Rezoning Transportation Analysis

Petition Number: 2022-147

Date	Description
1-25-23	First Review (IW)
2-22-23	Second Review (IW)

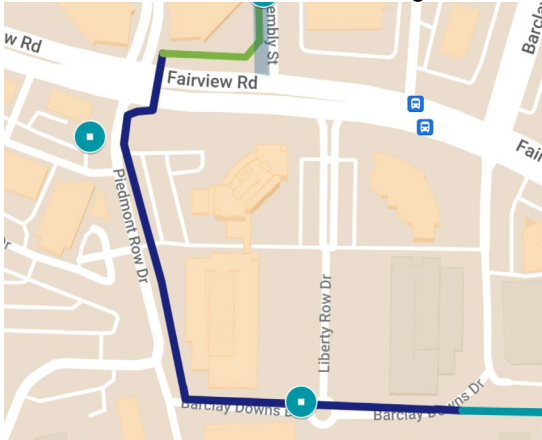
- Outstanding Comment from 1-25-23** Revise site plan and conditional note(s) to commit to dedicate 63 feet of right-of-way from the Fairview Road centerline. The site plan shall label and dimension the right-of-way from the road centerline.

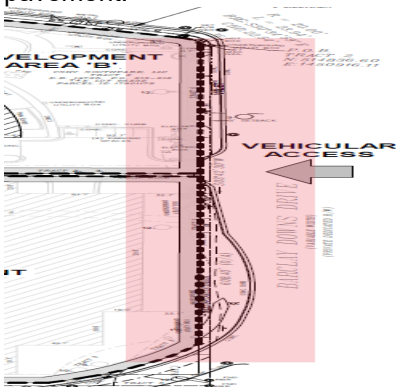
5. Revise site plan and conditional note(s) to commit to construct an 8-foot planting strip, and 12-foot Multi-Use Path on Fairview Road to support the City Council adopted Charlotte Streets map, and to meet the Council-adopted Charlotte BIKES Policy. Multi-use paths maintained by the City shall meet ADA/PROWAG requirements. The site plan shall label and dimension both items from the back of curb and gutter or edge of pavement.

Clarifying Comment 2-22-23: Update conditional note V.e. under Transportation to state “Sidewalks may meander to preserve exiting conditions where approved by CDOT and Urban Forestry.”
